Basic Development Plan and Basic Site Plan-

16-015BDP/BSP – Penzone Grand Salon

BSD Sawmill Center Neighborhood District

This is a request for a new one-story, 12,600 square-foot spa/salon, and associated site improvements on a portion of a ±3.544 acre site located at the northeast corner of the intersection of Riverside Drive and W. Dublin Granville Road. This is a request for review and recommendation of approval by the Administrative Review Team of a Basic Development Plan/Basic Site Plan Review under the provisions of Zoning Code Section 153.066.

Rendering of proposed site layout

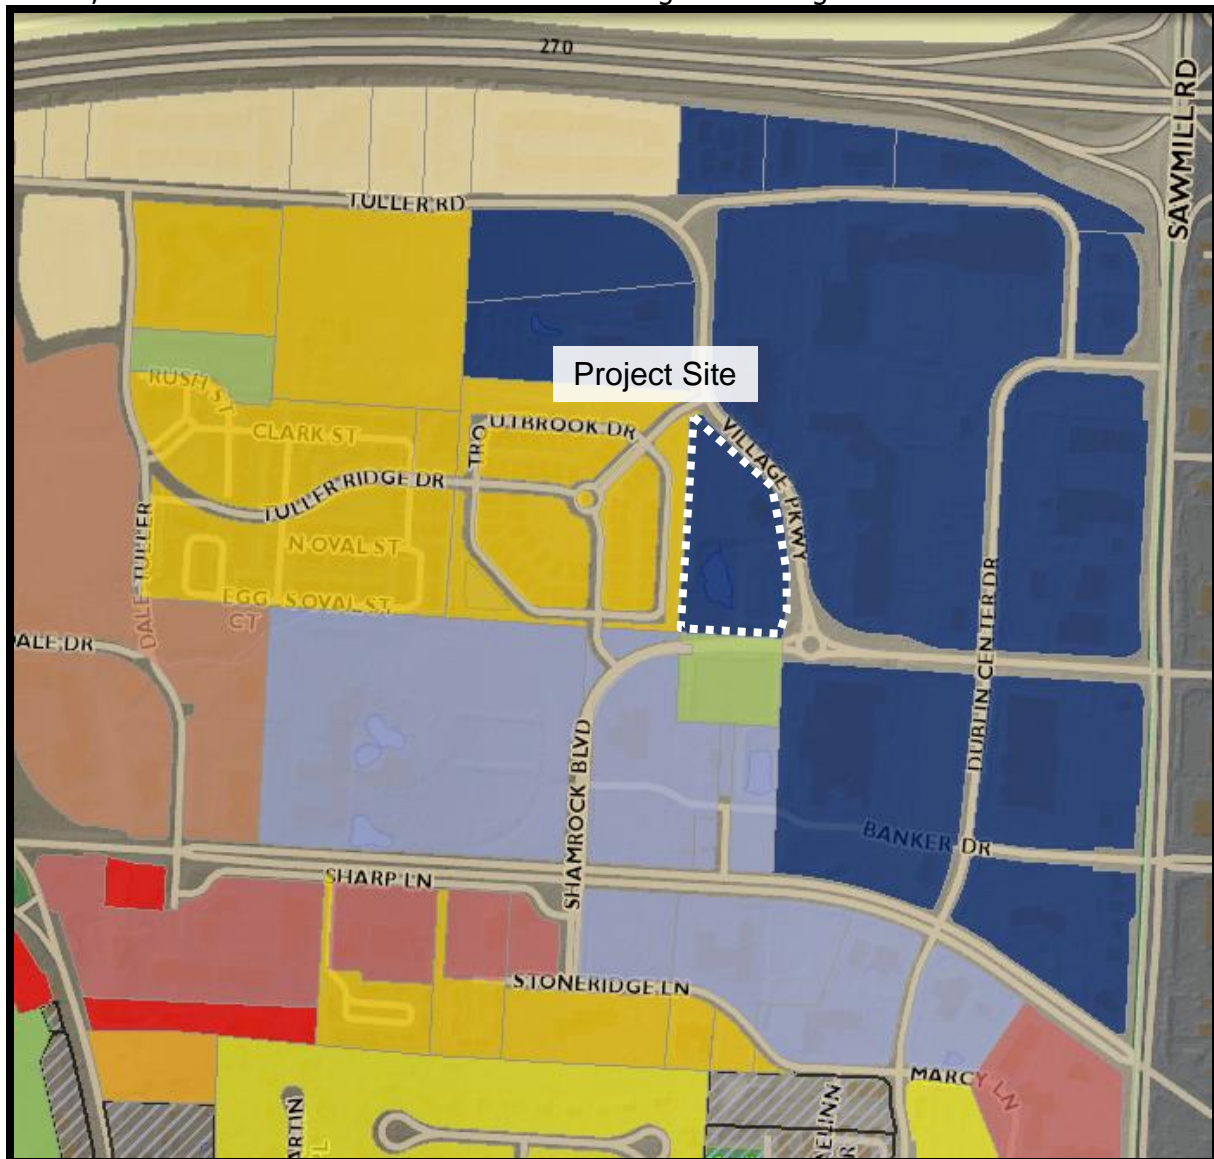
Streets. The site is accessed by an existing drive off Village Parkway on the east boundary of the property. Although the plan does not show extension of any streets, the applicant is required to dedicate 50 feet of right-of-way for the future development of a neighborhood street to conform with the Bridge Street District Street Network Map (§153.061). The District Street Network map illustrates a Neighborhood Street through the property. Without the dedication, the existing block bounded by Cooperstone Drive, Village Parkway, Shamrock Boulevard, and Hobbes Landing Drive East exceeds the maximum block length and block perimeter length permitted in the Sawmill Center Neighborhood District. The applicant will work with Engineering to finalize the details of the right-of-way dedication and access point from Village Parkway. No construction of the roadway will be required at this time. In the event that the adjoining property is developed, the neighborhood street will likely be constructed at that time.

Required Building Zone. The proposed salon does not meet the required building zone between 0-15 feet along Village Parkway. This is due to the site constraint with an existing ±50-foot electric easement along Village Parkway. A waiver will be required.

Parking. Parking for the facility will be on-site to the rear and side of the proposed salon. The applicant is proposing to exceed the maximum required parking, with a total of 80 spaces, while 30 are required. The parking calculations for the proposed use are a minimum of 25 spaces (2 per 1,000 sq.ft.) and a maximum of 32 spaces (125% of minimum). Staff, ART, and the Planning and Zoning Commission had concerns about the excess of parking on this site. The applicant has provided a detailed analysis of their

1. Building Type–Section 153.062(O)(4) – Minimum Building Height – 2 stories (required); ±31-foot high, one-story building (requested).
Criteria Met. Due to the intended use of the building, the applicant has maintained a one-story building is necessary to provide employees and clients the appropriate environment. The applicant has worked to provide additional height, a mezzanine area and variation in materials which will give an appearance of two stories. The request will enhance the function of this building and not result in a lower quality of design.

4. Building Type–Section 153.062(O)(4) – Front Required Building Zone – The structure is required to be located between 0-15 feet from the front property line. The southeast corner of the building is at approximately 23 feet at the edge of the easement boundary. The public space has been designed to give the appearance of a closer setback through plaza areas, walls, and landscaping.

7. Building Type–Section 153.062(O) (4) – Parking Location – The parking area is required to be located in the rear yard or within the building. The applicant has designed the parking area to accommodate their projected need that includes parking to the rear and side.

9. Site Development Standards–Section 153.065(B)(4)– Off-Street Parking Space and Aisle Dimensions – Maximum width 22 feet (required); ±24 feet off-street parking drive aisles (requested).

10. Building Type–Section 153.065(E)(2)(j)– Street Wall Standards – Street Walls are intended to be located within Required Building Zone. If an RBZ is occupied by a building, the street wall shall be installed along the same plane as the nearest building façade. Proposed street wall is approximately 27-feet to the east of the nearest building façade.

- 1) That the applicant submit a Parking Plan application with the Development Plan/Site Plan application
- 2) That the applicant submit a Preliminary and Final Plat application
- 3) That the applicant work with staff to determine location of neighborhood street right-of-way
